Southern Nuclear Operating Company
Vogtle Early Site Permit Application
Supplemental Information Regarding Safety Evaluation Report Open Items

**Supplemental Information for
Vogle ESP SER Open Items 2.5-1 and 2.5-3**

Comments on Open Item 2.5-1 of Vogtle ESP

Comments of Open Item 2.5-3
Martin Chapman

10-Hz Total Mean Hazard Curve

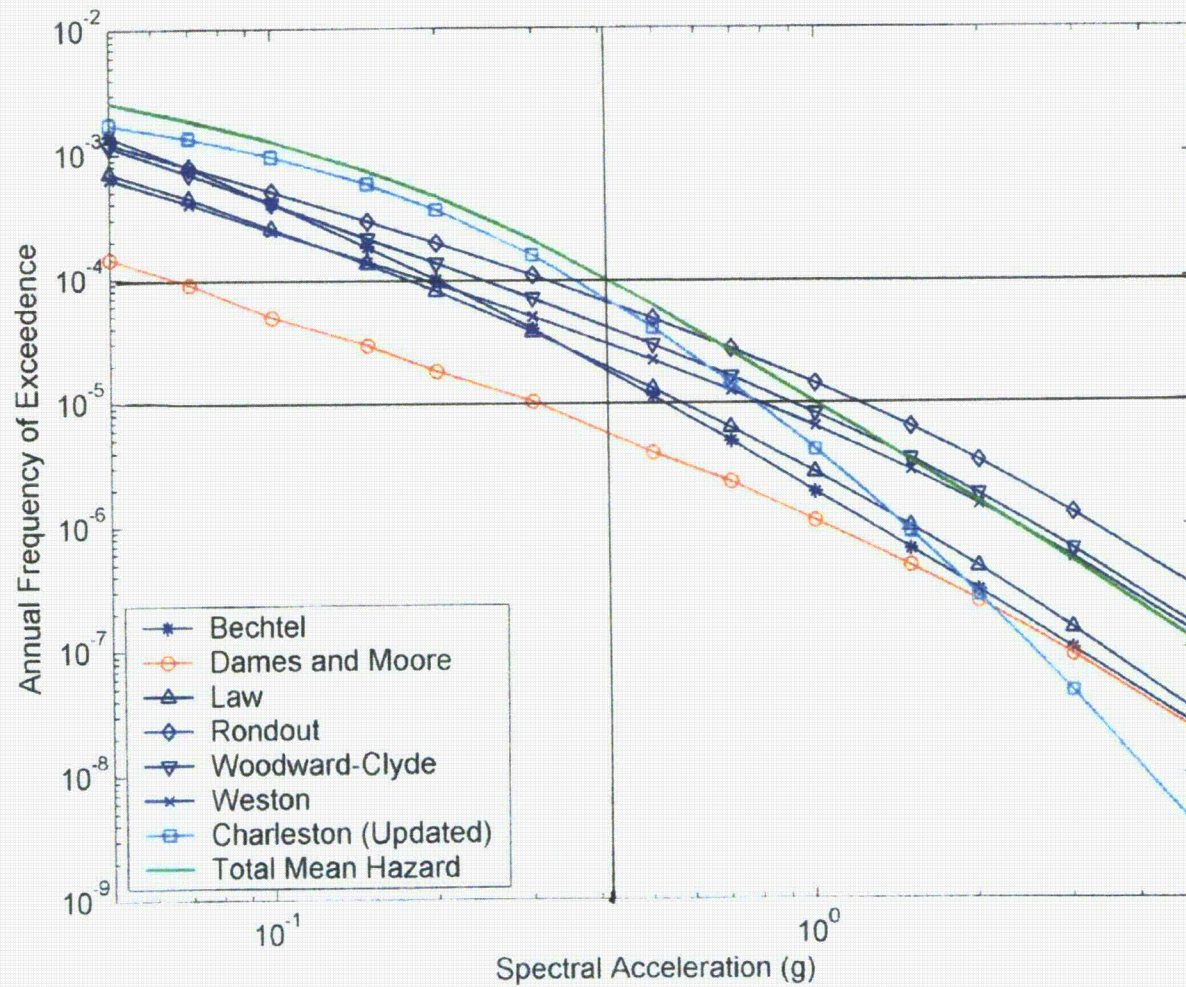
The attached figure shows the 10 Hz total mean hazard curve together with the contributing mean hazard curves from the updated Charleston source and each of the six ESTs source models. At any spectral acceleration SA, the total mean annual frequency of exceedance H is given by combining the Charleston source mean annual frequency of exceedance (AFE) with the mean of the 6 ESTs mean AFE, i.e.:

where H_C is the mean annual frequency of exceedance from the updated Charleston source, and H_R , H_{WC} , H_{We} , H_L , H_B , H_{DM} , are the mean AFE from the Rondout, Woodward-Clyde, Weston, Law, Bechtel, and Dames and Moore teams, respectively. At $SA=0.42g$, Table 1 lists the mean AFE scaled from the attached figure for each of the mean hazard curves, and the combined total.

It has been suggested by some people that the Dames and Moore source model should be revised or deleted because it produces outlier low H_{DM} results when compared to results from the other 5 ESTs. However, H_{DM} from the Dames and Moore source model is no more of an outlier than is H_R from the Rondout source model. Table 2 shows the change to H from deleting H_{DM} , deleting H_R , and deleting both H_{DM} and H_R .

Deleting H_{DM} increases the total mean AFE by only approximately 5%. Conversely, deleting H_R decreases the total mean AFE by approximately 7%. Deleting both H_{DM} and H_R decreases the total mean AFE by about 2%. It can be seen that at a mean AFE of 1.0×10^{-4} , the computed mean AFE are not significantly influenced by either H_{DM} or H_R . Furthermore, H_R from the Rondout team source model has more influence on the mean AFE than does H_{DM} from the Dames & Moore source model. Similar results exist at a spectral acceleration corresponding to mean AFE of 1.0×10^{-5} .

Neither the Dames and Moore team results nor the Rondout team results are outlier results. The difference in results simply reflects the diversity of scientific judgement. It would be capricious to discount or re-weight any of the ESTs results.
